New Hydraulic Check Valve

Mechanics, the hydraulic check valve, NSN 4820-00-732-3944, for the FAASV's auxiliary power unit (APU) is being replaced.

Install new hydraulic check valve and pipe elbow

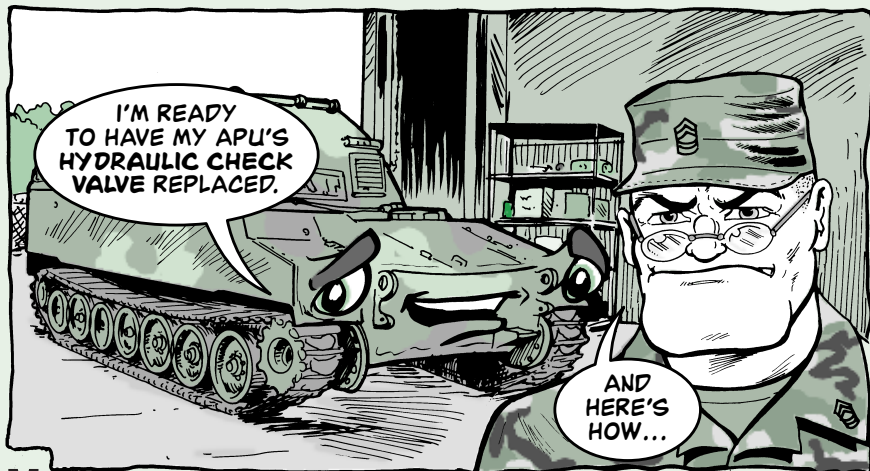
When the check valve goes bad, order check valve, NSN 4820-01-107-6115, and pipe elbow, NSN 4730-00-852-5654, to replace it.

1. With the vehicle shut down, remove the APU pump's inlet hose and adapter from the old check valve.
2. Remove the old valve from the tee. Toss the valve.
3. Install the new pipe elbow and check valve into the tee. Make sure the valve's arrow markings point in the direction of the tee.
4. Install the adapter into the check valve, then reattach the inlet hose assembly into the adapter.
